# Access Compliance Report

## Public Rights-of-Way

Intersection ID: 3274	Main Street: MALLARD_GREEN_PL	Cross Street: SHELLY_PINES_DR	Location: S
ADA ID: 89A4A92D51EF	Ramp Type: Perp	Initial Pass/Fail: Fail	Overall Compliance: No
Severity Score: 22.5			
Codes/Mitigation Info/Possible Solution		Field Measurements/Component Compliance

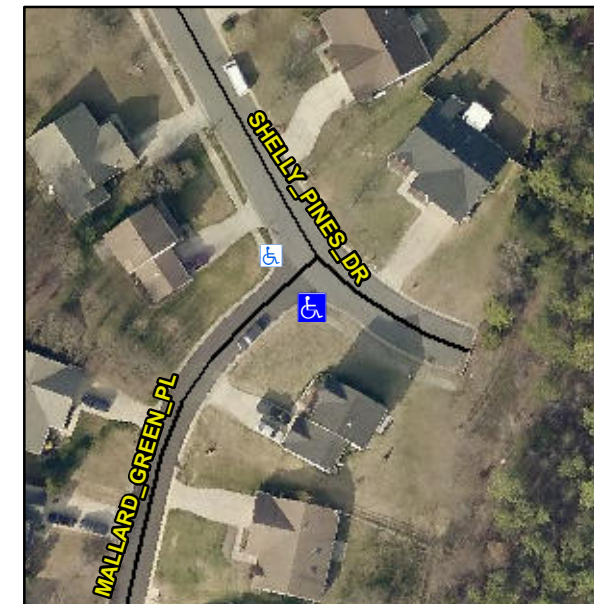
**R304.5.1, R304.2.2, R304.5.3**

Compliance	Description	Data	Compliance	Description	Data
N/A	Ramp Length (in)	46.0	No	Ramp Slope (%)	9.4
No	Ramp Width (in)	39.0	No	Ramp XSlope (%)	3.0
N/A	Flare Type LT	N/A	N/A	Flare Type RT	N/A
N/A	Flare Slope LT (%)	N/A	N/A	Flare Slope RT (%)	N/A
N/A	Flare Traversable LT?	N/A	N/A	Flare Traversable RT?	N/A
N/A	Landing Length (in)	N/A	N/A	DWS Provided?	N/A
N/A	Landing Width (in)	N/A	N/A	DWS Contrast?	N/A
N/A	Landing Slope (%)	N/A	N/A	DWS Length (in)	N/A
N/A	Landing X Slope (%)	N/A	N/A	DWS Full Width?	N/A
N/A	Landing Curb? (Y/N)	N/A	N/A	DWS Offset (in)	N/A
N/A	Shared Landing?	N/A			
N/A	Gutter Ponding?	N/A	N/A	Gutter Slope (%)	N/A
N/A	Gutter Lip Ht (in)	N/A	N/A	Gutter X Slope (%)	N/A
N/A	Painted X Walk1?	No	N/A	Painted X Walk2?	N/A
	X Walk 1 Direction	To NW		X Walk 2 Direction	N/A
N/A	X Walk 1 Width (in)	N/A	N/A	X Walk 2 Width (in)	N/A
	X Walk 1 Slope (%)	2.5		X Walk 2 Slope (%)	N/A
	X Walk 1 X Slope (%)	3.0		X Walk 2 X Slope (%)	N/A

**Remove & Replace Entire Ramp.**
